ADDENDUM NO. 2

**Three Rivers Community Schools – Three Rivers Middle School Additions and
Renovation**

SHEET CLARIFICATIONS / REVISIONS

ENLARGED UNIT 'D' MECHANICAL MEZZANINE
HYDRONIC DEMOLITION PLAN

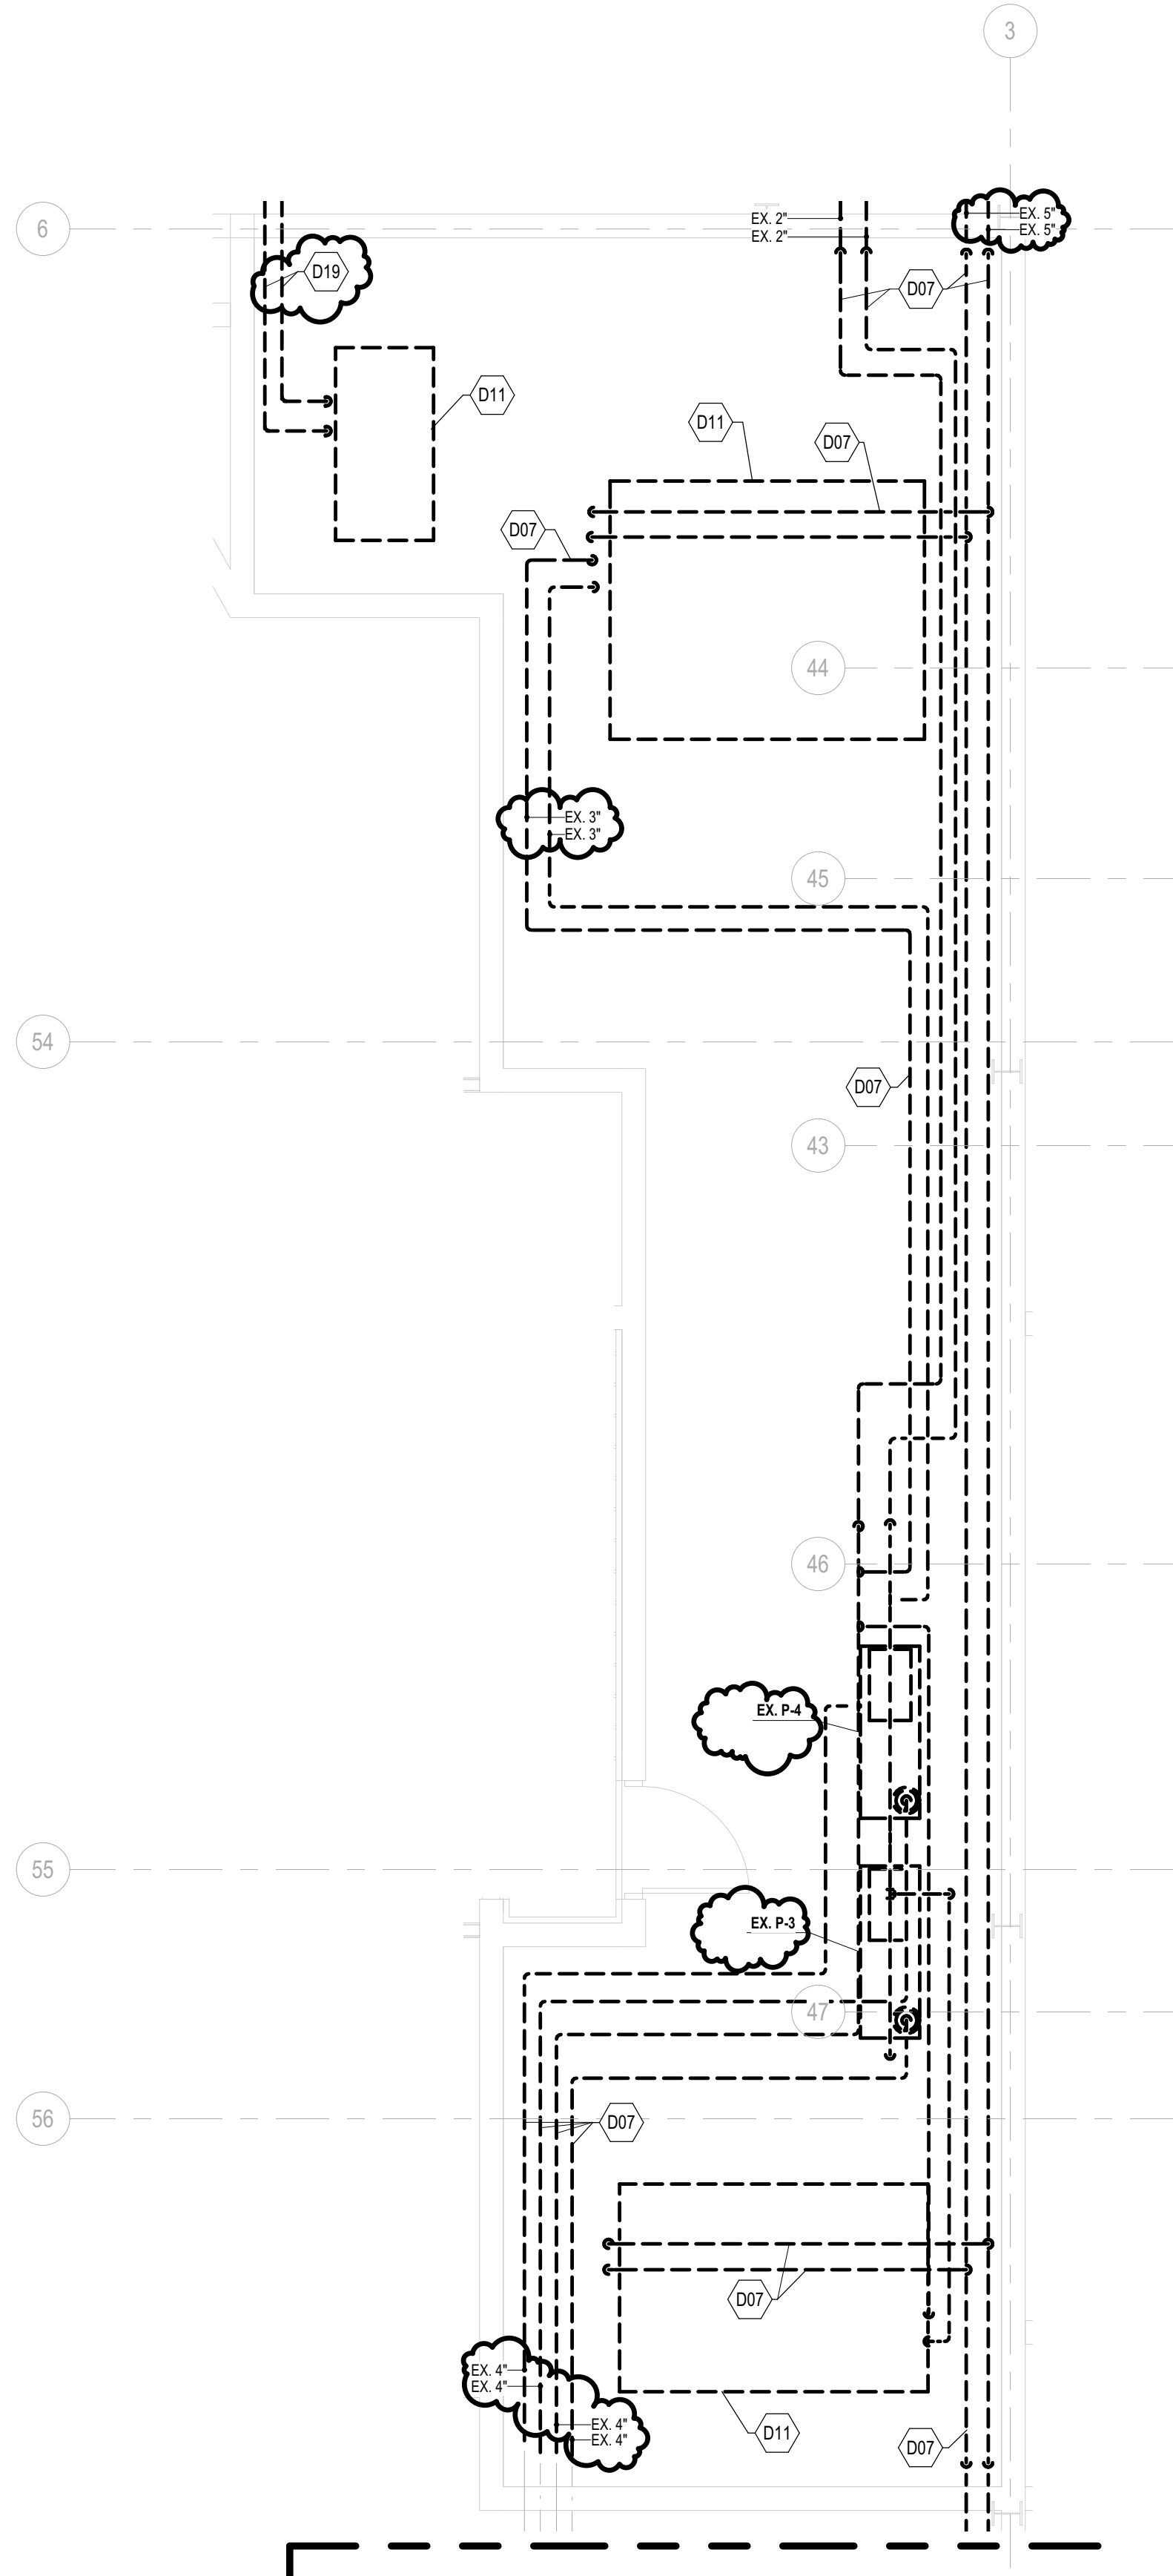
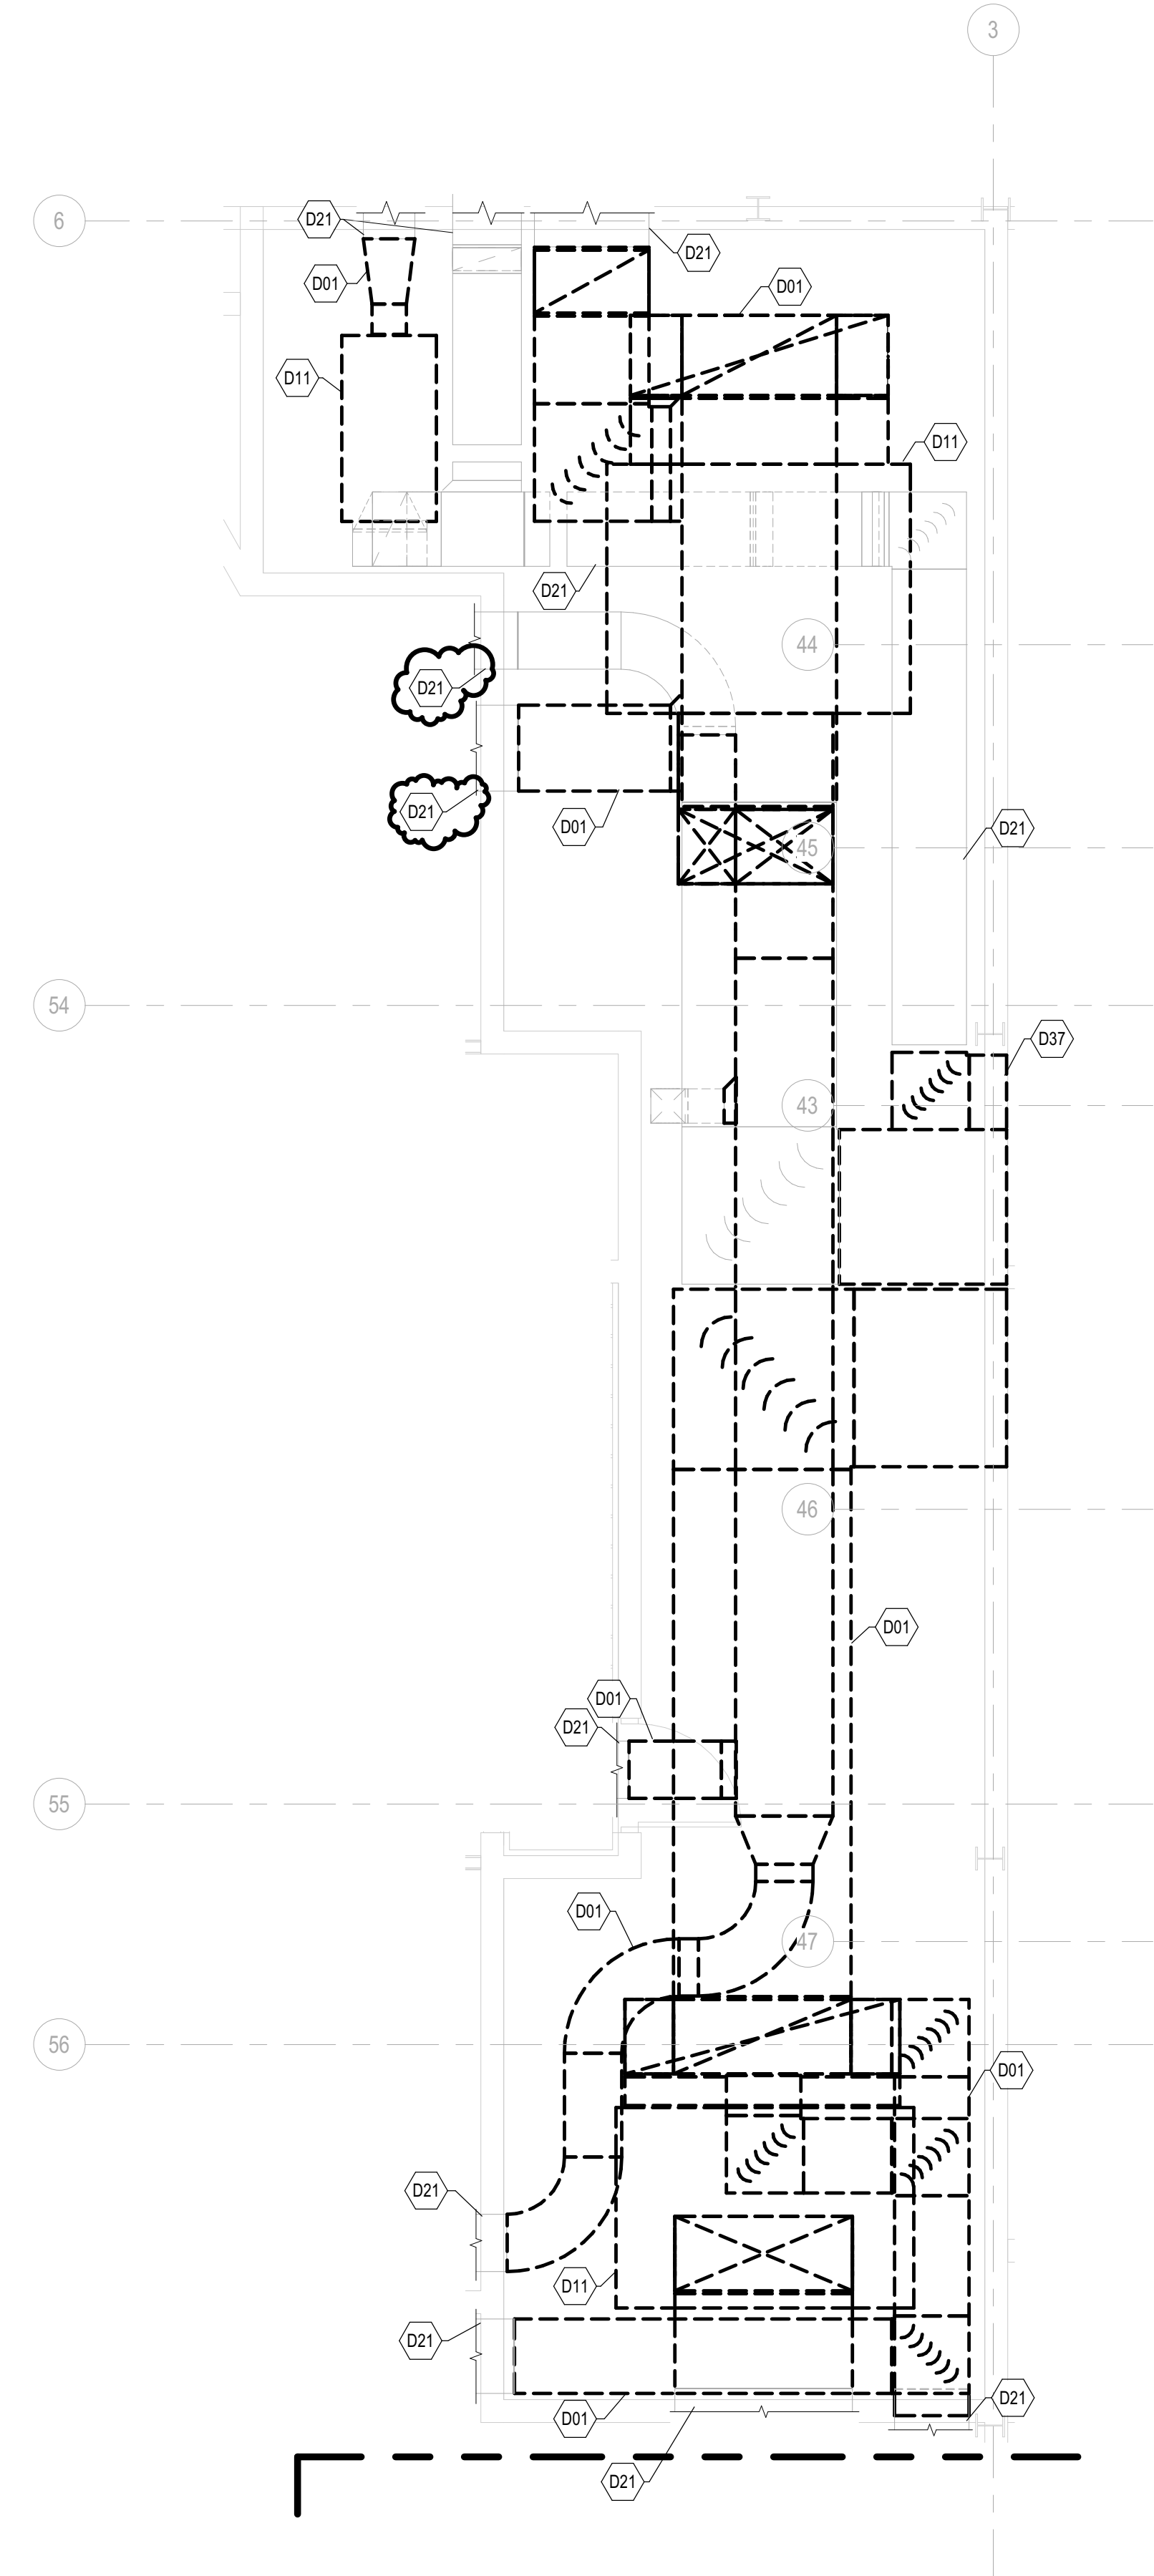
ITEM NO. 34 **SHEET M1.81 ENLARGED MECHANICAL DEMOLITION PLANS (REISSUED)**

- A. Added and revised mechanical keynotes.
- B. Revised Mechanical Demo Keynote Legend.
- C. Added general note to describe Base Bid and Alternate M-1 work on the drawing.

UNIT 'A' HVAC PLAN
1/8" = 1'-0"

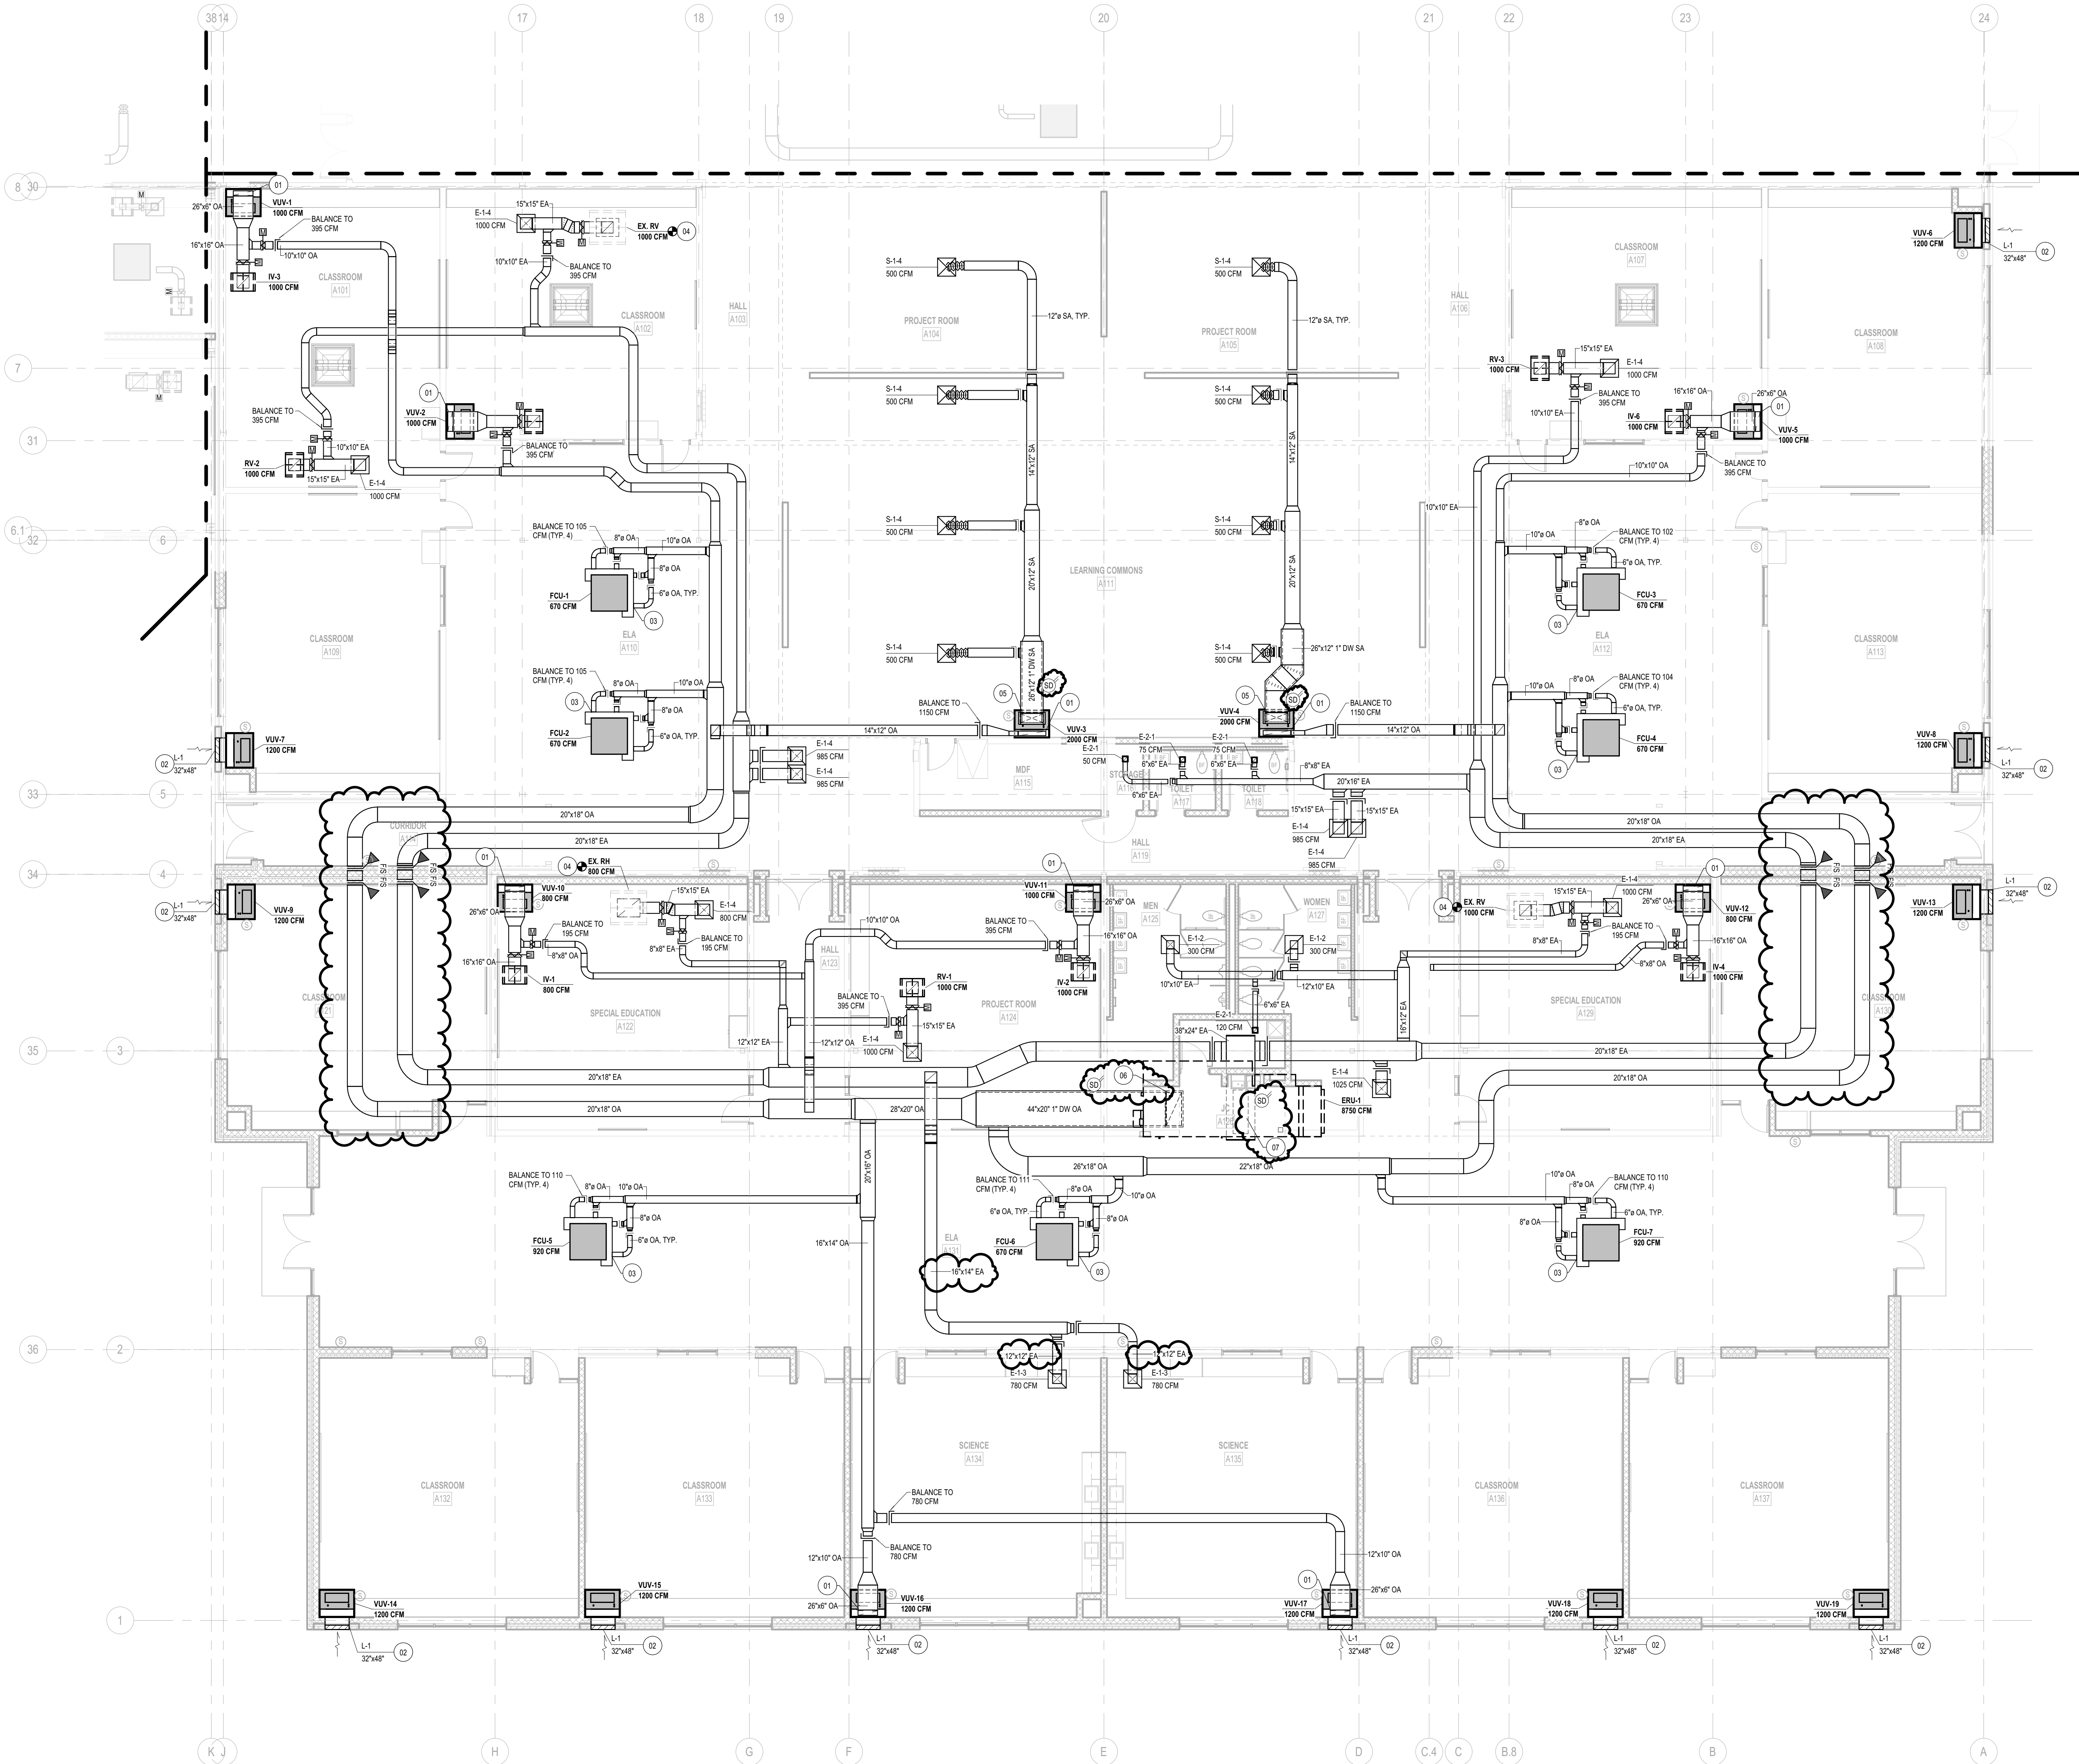
ITEM NO. 35 **SHEET M2.1A UNIT 'A' HVAC PLAN (REISSUED)**

- A. Added mechanical keynotes.
- B. Revised Mechanical Keynote Legend.
- C. Added ductwork sizes and fire/smoke dampers.
